Service Letter No. 140

SUBJECT: Rudder Cable Rub Block - PA-20 Airplanes serial 20-1 to 20-48 incl., 20-50, 20-52 to 20-83 incl., 20-85 to 20-88 incl., 20-90 to 20-94 incl., 20-96, 20-98 to 20-104 incl., 20-106 to 20-109 incl., 20-112, 20-114, 20-116 to 20-118 incl., 20-121 and 20-128.

RUDDER CABLE RUBBLOCK (meo)	
SERVICE LETTER	# 140
PIPER AIRCRAFT CORPORATION	
LOCK HAVEN, PENNSYLVANIA

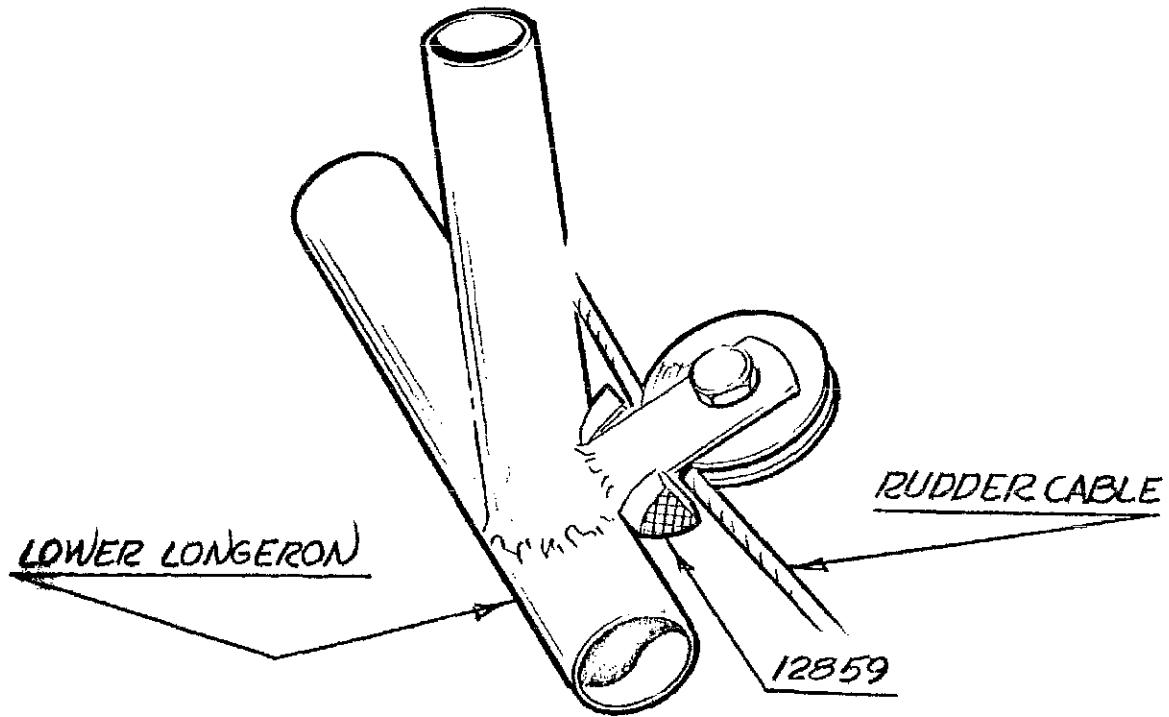
It has been brought to our attention that there is sufficient slackness in both the right and left rudder cables of the PA-20 to permit the cables to ride on the edge of the four pulleys located under the front and rear seats on both sides of the cockpit. In order to eliminate the aforementioned condition, we are sending to you, at no charge, four cable rub blocks, Part Number 12859-00, which should be installed using the following procedure. (See Sketch opposite side.)

1. Remove the rear seat cushion and frame.
2. Fold the edge of the cockpit back so as to permit easy access to the screws which hold the pulley guards.
3. Remove the four rudder cable pulley guards.

4. Remove the four pulleys, being careful not to lose the small bushings or washers. It may be necessary to loosen the forward end of both rear tunnels to permit removal of the cable from the pulley housing.

5. Lift the cable out of the pulley housings. Insert a cable rub block, number 12859-00, into each of the four pulley housings, making certain that the block seats properly. It is only necessary to have sufficient clearance between the pulley and block to allow the pulley to rotate freely. (It is imperative that the pulley runs freely.) It may be necessary to file the fibre block slightly to insure proper fit. The rub blocks will hold the cable in the pulley groove at all times.

6. Reinstall the cable and pulleys; rudder pedal guards and seat.
